1.0 DEFINITIONS

CORE OPERATING LIMITS REPORT

SUMMER - UNIT 1

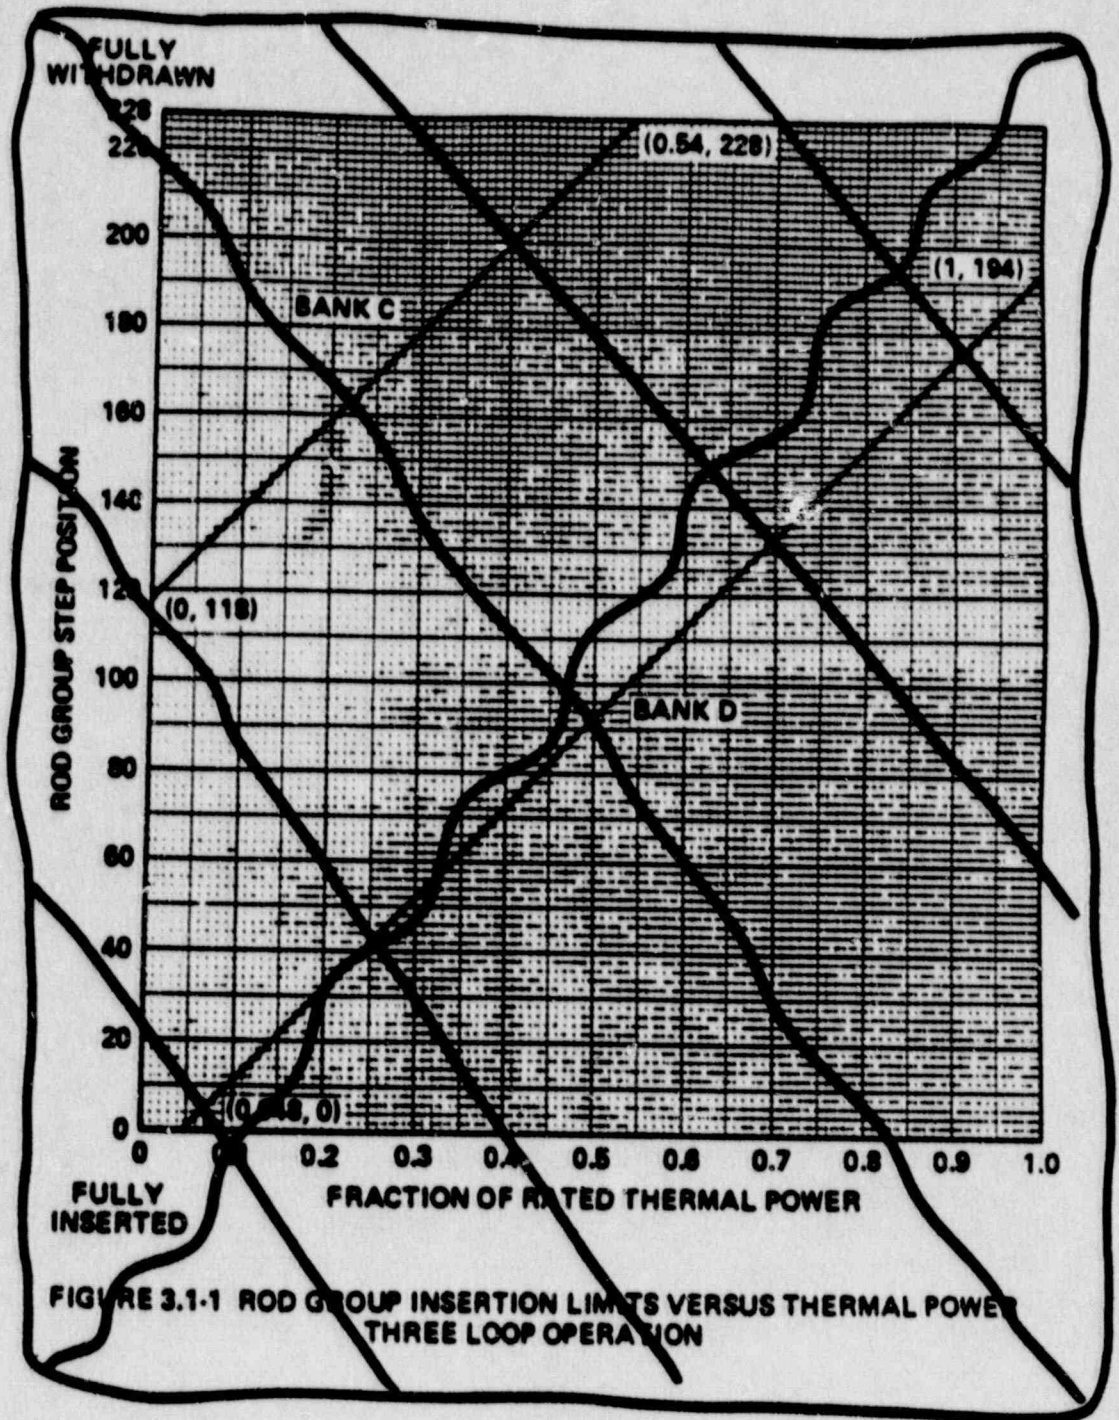
Delete figure from Tech Spec and Supply
Cycle Specific Figure in CORE OPERATING
LIMITS REPORT.

3.1.3.6 The control banks shall be limited in physical insertion as ~~shown~~ ^{specified} in the CORE OPERATING LIMITS REPORT (COLR) figure entitled APPLICABILITY: MODES 1* and 2*#. *Rod Group Insertion Limits Versus Thermal Power For Three Loop Operation.*

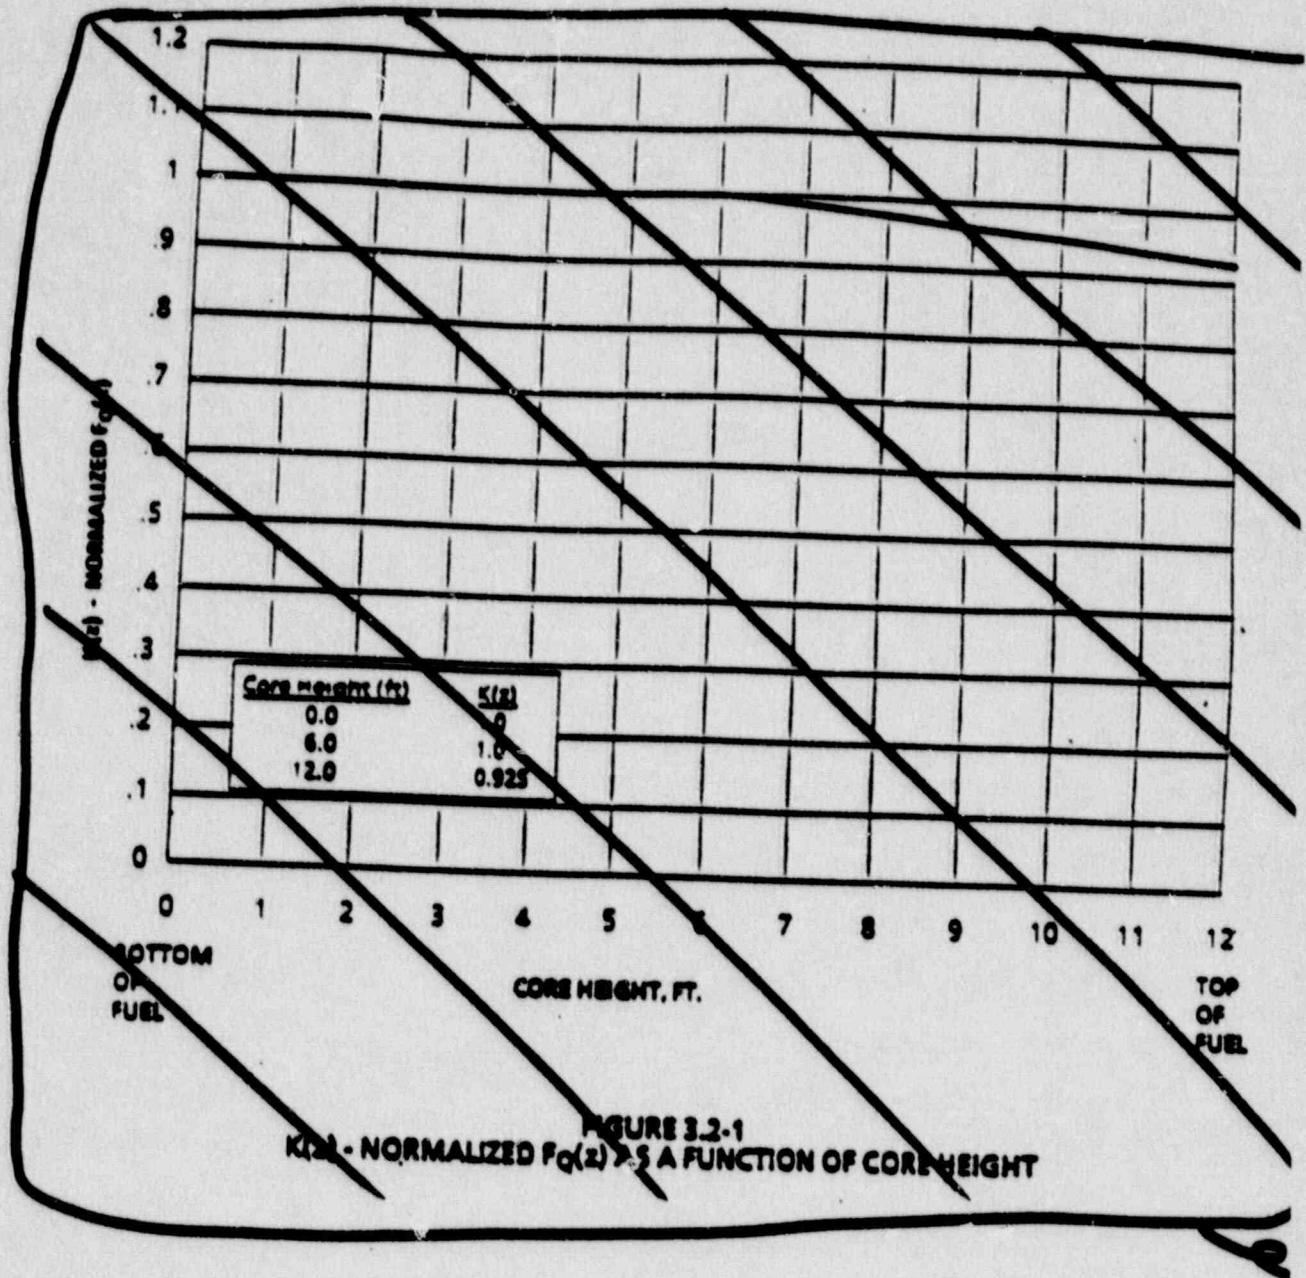
DELETE FIGURE IN TECH SPEC
RELOCATE K(z) TO COLK.

$K(z)$ = the ~~maximum observed factor~~ *normalized $F_Q(z)$* for a given core height ~~location~~ *specified in the COLR.*

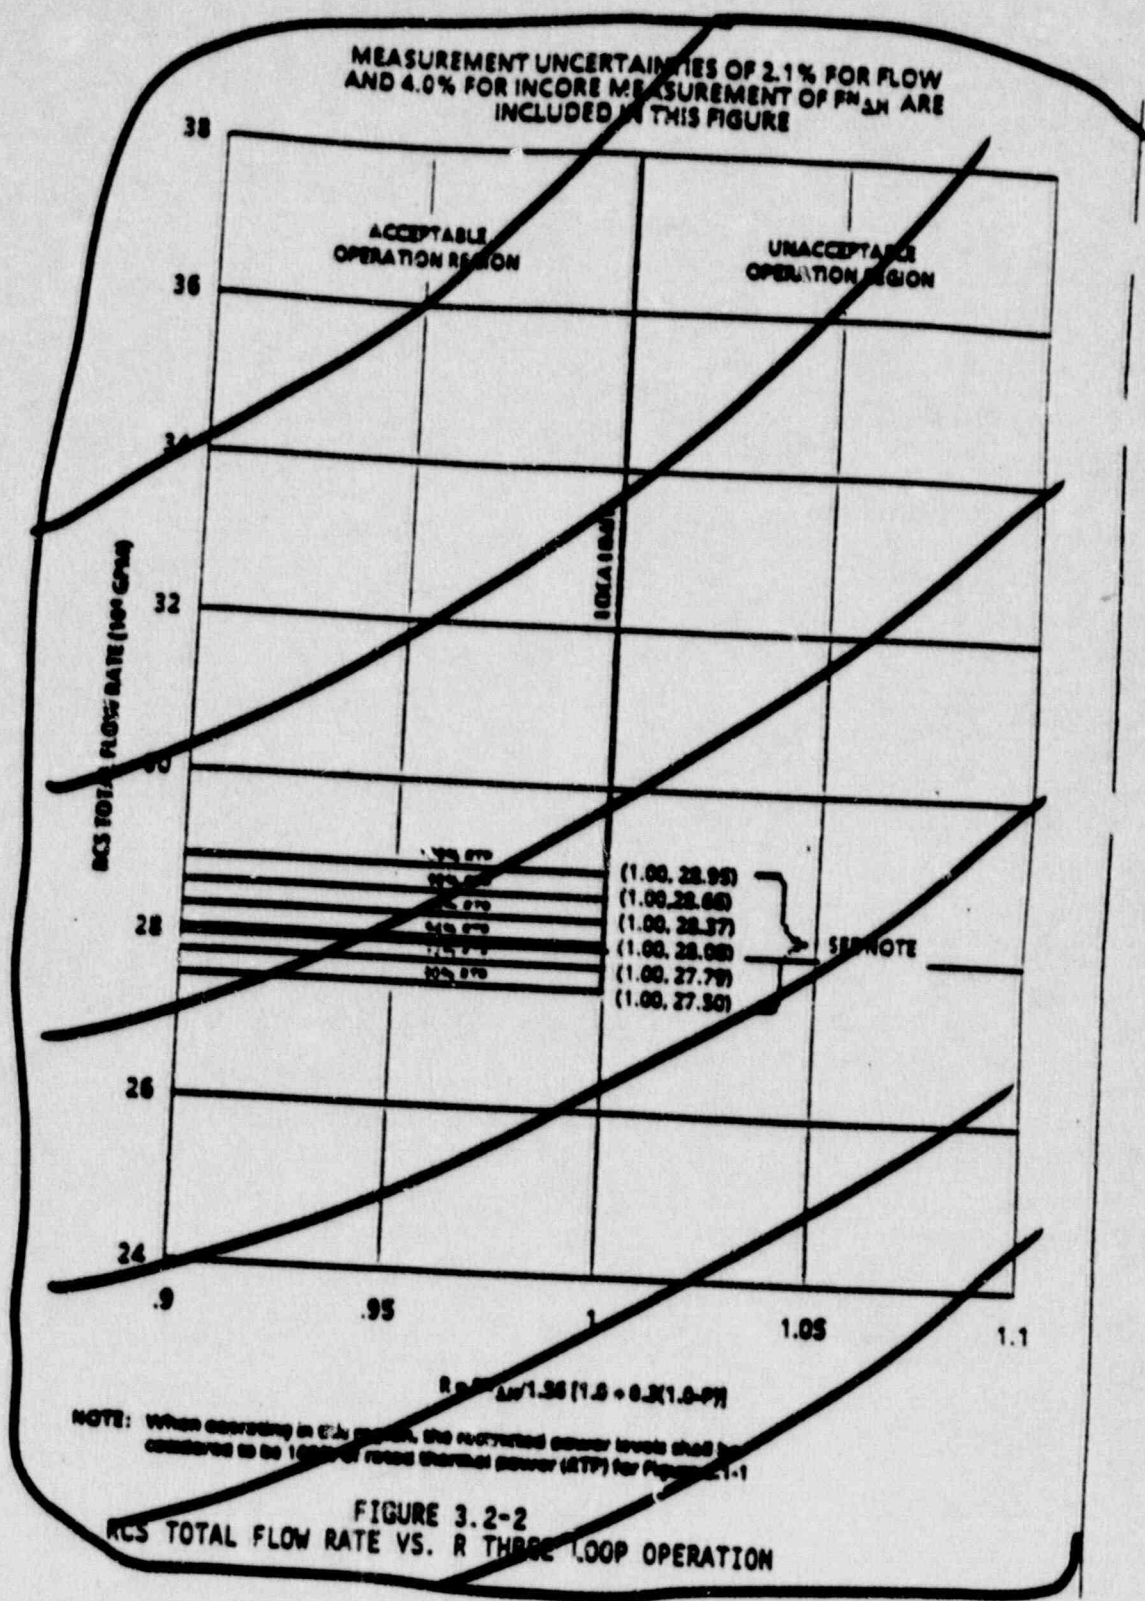
DELETE FIGURE FROM TECH SPEC
 RELATE TO COLL.

as specified in the CORE OPERATING LIMITS REPORT (COLR) figure entitled RCS Total Flow Rate Versus R for Three Loop Operation.
